TMPR3927 Specification Update

Revision History

TMPR3927F, TMPR3927AF, TMPR3927BF, TMPR3927CF

| TX39Family TMPR3927 DataBook | (2002):Doc.No= 44150D-0112 |

Figure 1 Unnecessary STOP* signal assertion operation

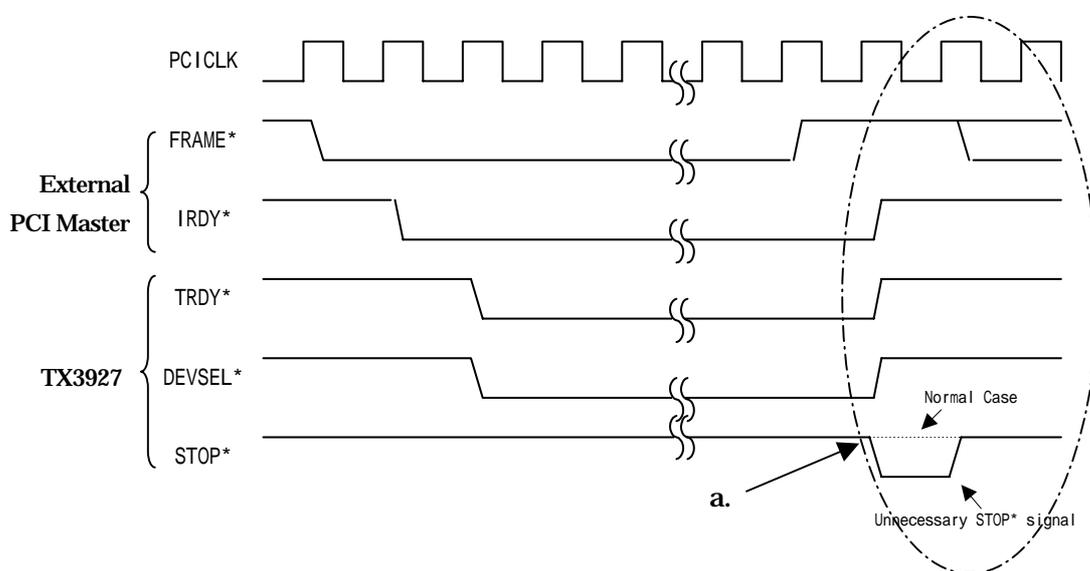
Under particular conditions, the PCI controller in the TX3927 may assert unnecessary STOP* signals.

As illustrated in Figure 1 below, the PCI controller in the TX3927 may, under particular conditions, assert unnecessary STOP* signals when the external PCI master is performing burst access to the TX3927 local memory, exactly when the burst cycle ends (a. in Figure 1).

This phenomenon occurs under the following conditions:

- (1) When the burst cycle is in the Read state
 - If OFIFO becomes empty just before timing a. (in the above figure) when the target control register (TC : address 0xFFFE_D090) in the PCI controller has set OFIFO8 Clock Rule Enable (OF8E : bit 3) to "Disable."
- (2) When the burst cycle is in the Write state
 - (a) If IFIFO becomes full just before timing a. (in the above figure) when the target control register (TC) in the PCI controller has set IFIFO8 Clock Rule Enable (IF8E : bit 4) to

- (b) If the CPU core requests the bus at timing a. (in the above figure) while an other bus master of an internal bus is executing a bus cycle and PSNP (PCI snoop : bit 11) of the chip configuration register (CCFG) has been set to “Disable.”

- (1) When the burst cycle is in the Read state
Set OF8E of the target control register (TC) in the PCI controller to “Enable.”
- (2) When the burst cycle is in the Write state
Set IF8E of the target control register (TC) in the PCI controller to “Enable,” and also set PSNP of the chip configuration register (CCFG) to “Enable.” In this situation however, it is prohibited to use the Data cache in the Write-back mode.

- (1) It is possible to set PSNP of Chip Configuration Register to “disable” so as to use the Data cache in the Write-back mode.
- (2) There is still the usage limitation to set OF8E and IF8E of the target control register in the PCI controller to “Enable” whenever it is possible to execute PCI burst cycles.

【Table of AC Characteristics(SDRAMC, ROMC signals)】

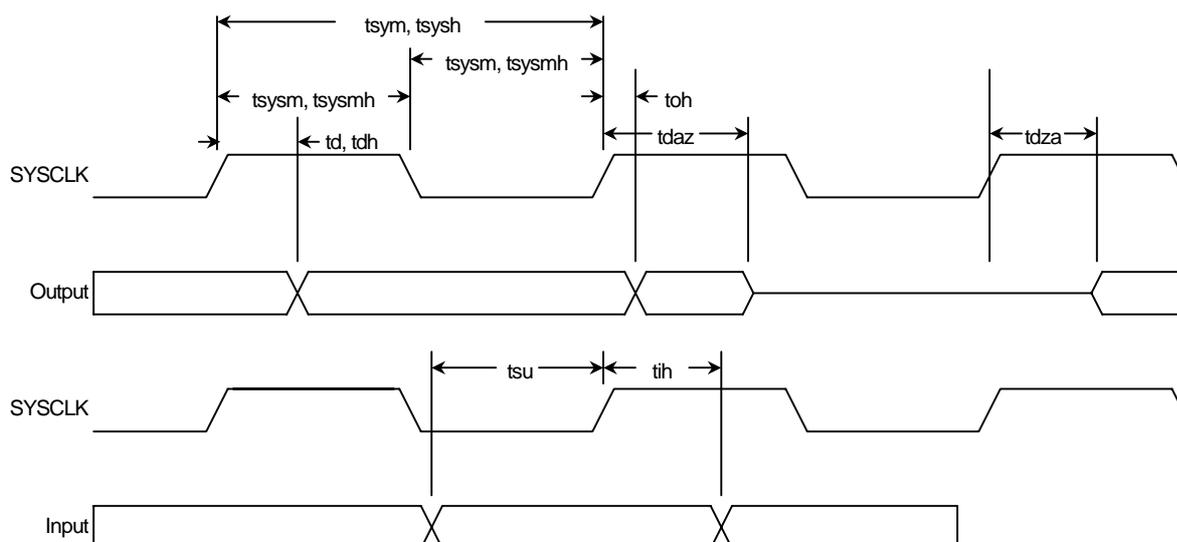
Difference

The spec of Output Delay is defined respectively in the full-speed mode(t_d) and the half-speed mode(t_{dh}).

In the half-speed mode, the spec of ADDR, ACE*, CE*, OE* and BE* differ from these of the other signals.

- (2) Design a system based on new AC specification.
- (3) Use the ROM controller only in the full speed mode.

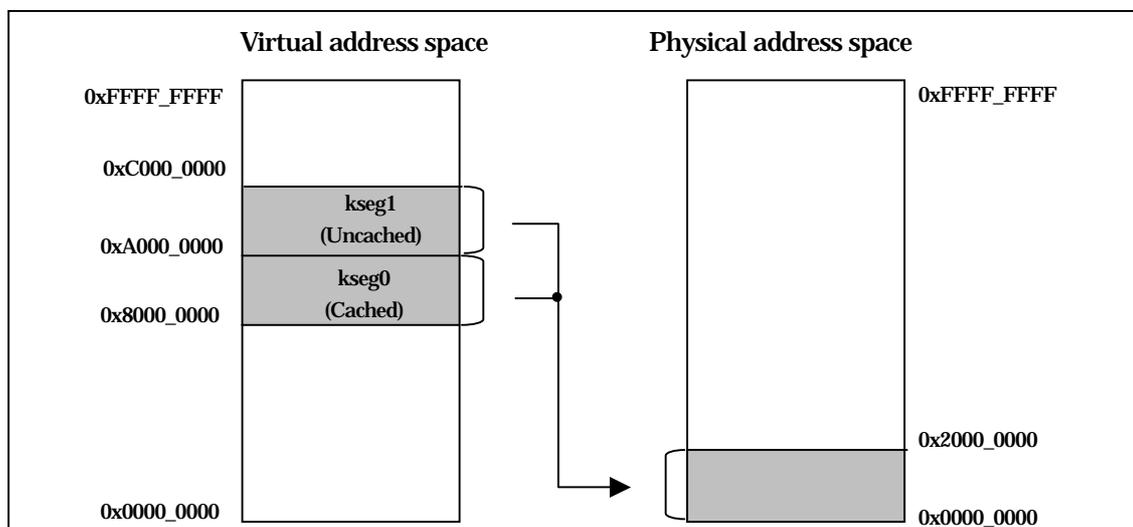
0x8000_0000~0x9FFF_FFFF and 0xA000_0000~0xBFFF_FFFF in virtual address is allocated in same physical address (0x0000_0000~0x1FFF_FFFF). 0x8000_0000~0x9FFF_FFFF is cached area, and 0xA000_0000~0xBFFF_FFFF is uncached area.

So reading data from cached area and writing the data to uncached area whose physical address is the same as

reading address is equal to flash of data cache by CACHE instruction.

For example, if data address that is target of cache flash is 0x8000_0000, please operate following 1) - 3).

1) Read out data from 0x8000_0000.

2) Write data that was read in phase 1) in 0xA000_0000.

3) Invalidate data cash for an address of phase 1). It is possible by setting op-field (bit20:16) of CACHE instruction with 0x11.

(abnormal movement)

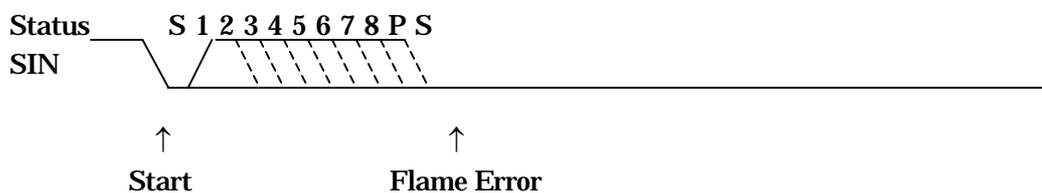
When the transmitter sends break signal in the middle of sending data, the TX3927 detects only the first framing error, and it can't detect a break signal

- The receive status stops as Idle, because the start bit after flaming error can't be recognized.

(normal movement)

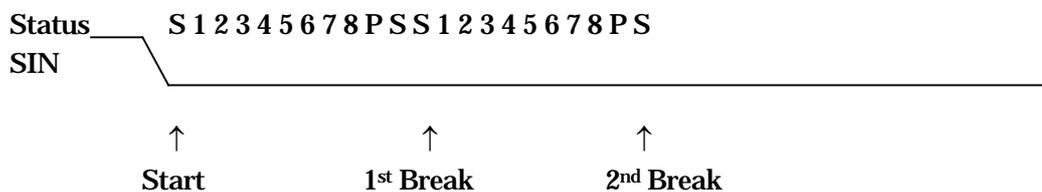
The TX3927 can detect break signal normally, when break signal is synchronized with start bit (The received data is low continuously right after the start bit recognition.).

- The break signal can be detected normally, when the received data is low continuously right after the start bit recognition.

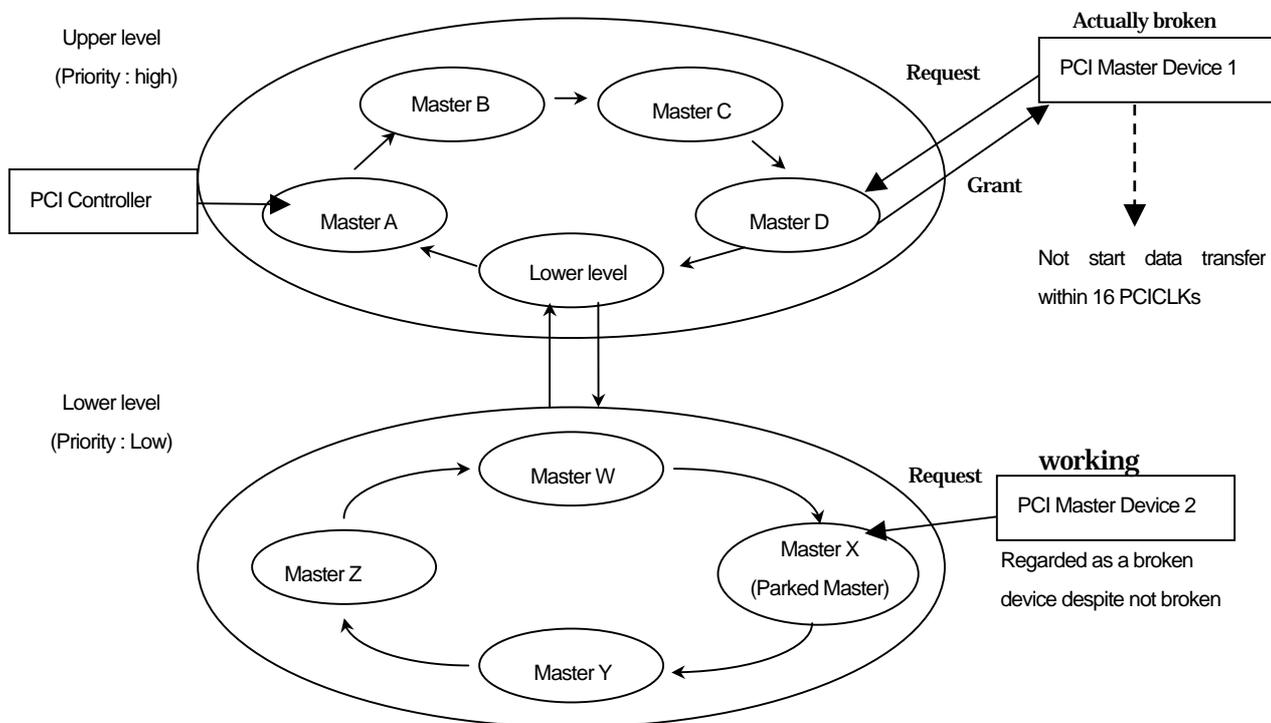
If you enable "PCI broken master check function", a working master device may be regarded as a broken master device and detached from PCI bus arbiter.

(1) Set Broken Master Check Enable bit. (BMCEN=1)

This bit is bit 0 of PCI Bus Arbiter /Parked Master Control Register (PBAPMC). Default is 0.

(2) There are two PCI bus arbiter groups, one is upper level and the other is lower level. (Please see the following figure) The assignment of PCI bus master devices to the bus arbiters is specified in Request Trace Register (REQ_TRACE)
